SUBDIVISION COMMITTEE
METROPOLITAN AREA PLANNING COMMISSION

STAFF REPORT
(Preliminary Plat)

CASE NUMBER: S/D 88-94 - HERITAGE HILL ESTATES

VICINITY MAP:

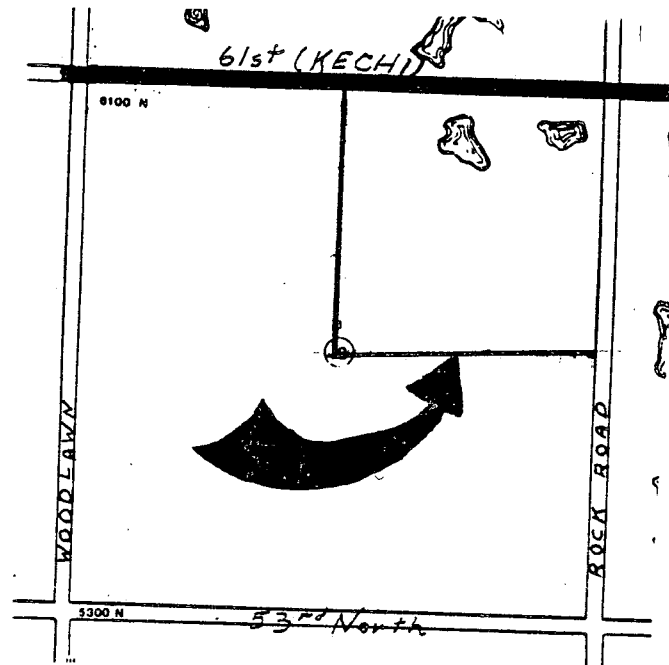
- A. Since neither municipal water nor sanitary sewer is available to serve this property, the applicant shall contact the Environmental Health Division of the Health Department to find out what tests may be necessary and what standards are to be met for approval of on-site sewerage facilities and water wells. A memorandum shall be obtained specifying approval.

- B. The applicant shall guarantee any drainage improvements required by the platting of this property.
- C. The applicant shall guarantee the construction of the proposed interior streets to suburban street standards.

- E. The applicant is advised that the County does not have the authority to accept the "rural water district easement" on behalf of Rural Water District #1. Therefore, the final plat shall either show the 20-foot rural water district easement, indicated on this plat, as being granted by separate instrument to the water district or the said easement shall not be shown on this plat. Should Rural Water District #1 accept the easement, then, the final plat tracing shall indicate the film and page of the legal document.

- F. The area indicated as "Roadway Easement" shall be dedicated out-right as public right-of-way. This is necessary to provide adequate access and frontage for Lots 7 and 10 Block 1 and to provide for the orderly development of adjacent properties.

- G. The final plat shall indicate the platting of "complete access control" to 61st Street North (Kechi) across the north line of this plat and across the east line to Rock Road excluding the two street openings to and from Rock Road. The final plat shall indicate this dedication on the face of the plat and in the platter's text to the appropriate governing body.

- H. The street names shown on this plat are redundant and could potentially lead to confusion for emergency services and mail delivery. Three separate and distinct names shall be used to indicate the difference in street address. We recommend Heritage Hill Drive be shown as 60th Street North; Heritage Hill Lane be shown as Rutland; and Heritage Hill Road be shown as Heritage Hill Lane.

- I. The applicant is advised that the building setbacks as shown on the preliminary plat are beyond what would be required to plat this site. Should the applicant desire less restrictive setbacks they should be determined and set at the time of submitting the final plat. Setback lines and dimensions shall be indicated within the lots and not in legend form.

- J. The intersection of the two interior streets with the right-of-way of Rock Road, along the east line of the plat, shall be shown with dashed lines, not solid lines. Solid lines indicate the plating of private streets.

- K. The preliminary plat indicates a 100 foot building setback from North 61st street (Kechi) through an existing barn which encroaches into the setback area. County Public Works has advise that the platting of this building setback does not preclude the property owner from maintaining or remodeling that portion of the building within the setback area. The building cannot, however, be enlarged within the setback and, if the building is removed, any new building construction must observe the platted building setback.

- L. The final plat shall reference a tie point to a previously platted lot corner or section corner.
- M. The final plat tracing shall indicate angles or bearings for the perimeter of this plat.

- N. The final plat shall label the center lines of the adjacent perimeter roads (Rock Road & 61st Street North) as well as provide arrows for more clearly indicating the amounts of half-street rights-of-way.
